Docket Item #13
DEVELOPMENT SPECIAL USE PERMIT #2003-0019
THE MONARCH (HENNAGE PROPERTY)

Planning Commission Meeting
November 4, 2004

ISSUE: Consideration of a request for a development special use permit, with site plan and modifications to construct a residential building with ground floor retail.

Proposed Henry Street Elevation with Staff Recommendation

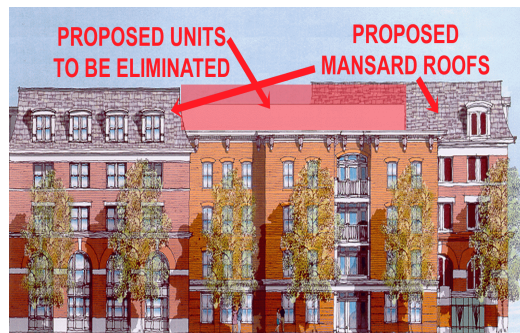
6 ft. to 14 ft. from the property line. The building elements on the southern portion of the site are intended to emulate traditional mixed-use buildings on King Street or other areas within the City. The building on the northern portion of the facade is an Art Deco facade, recalling a more industrial scale reminiscent of the early 20th century. Staff believes that a sheer height of six-stories along North Henry Street across from the lower scale residential is too imposing, and therefore recommends the elimination of the upper level on the northern warehouse-type building element to reduce the overall mass. In addition, staff recommends the continued refinement of the corner tower as a defining element of the project, particularly as seen from the approach from the north on Henry Street.

- o. Each bay for building #2 shall provide a variation in brick colors to provide the appearance of separate buildings.
- p. For building #1, two units shall be eliminated on the Henry Street facade as generally depicted in *Attachment #1*. The facade as generally depicted in *Attachment #1* shall be revised to provide the appearance of a more traditional style and a three-story element rather than the five-story element as currently depicted. The roof for the upper floor of this element shall be slate or synthetic slate.

Proposed N. Fayette Street Elevation with Staff Recommendations

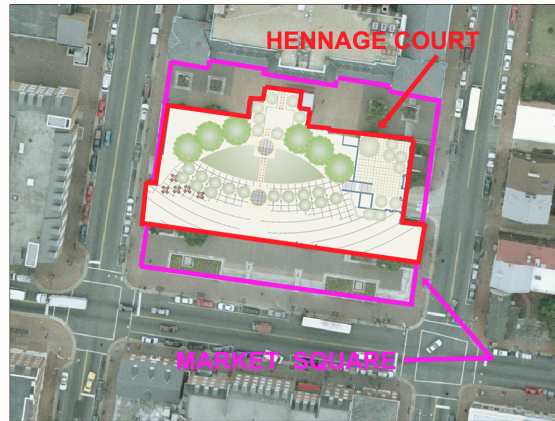
The Oronoco Street Facade is one of the shortest elevations and contains the principal entrance for the condominium building on the south half of the site. The proposed building consists of three sections facing Oronoco Street: the three-story, mixed-use element from the corner at Henry Street; the central portion which contains the entrance in a Queen Anne or late Victorian mixed-use building; and a 5-story level commercial type building at the corner of Fayette Street. The three buildings are connected by two architectural hyphens that serve as internal walkways for the units. The hyphens are setback approximately 30 feet from the face of the adjacent buildings and reinforce the impression of separate architectural pieces. The overall composition of mixed-use multi-family buildings is a reasonable approach but the scale of the proposed 5-story element at the corner of Oronoco and Fayette Streets is too imposing for the adjacent neighborhood, both in its height approximately 50 ft. feet and in the monumental language of three-story columns, large-scale windows, heavy entablature, etc.

Therefore, staff recommends that the corner element be reduced in its visual impact, both by modifying the style to a less grandiose expression and by eliminating a portion of the fifth floor so that the building will appear as a four-story building from the adjoining streets. This modification will result in the elimination of approximately three units. The elimination of the units also occurs on the accompanying Fayette Street facade and is essential to enable a better transition to the adjoining two-story buildings.

- w. The southeastern portion of the building shall be revised as generally depicted in *Attachment # 3*. The roof for the upper floor shall be slate or synthetic slate.
- x. The base for building # 4 shall incorporate the use of windows proportioned to the size of the base of the building.
- y. A different material or banding shall be provided at the upper level to simulate the appearance of a cornice.
- z. Details of the tower element shall be refined to the satisfaction of the Director of P&Z and shall be included in the elevations submitted for review with the final site plan.
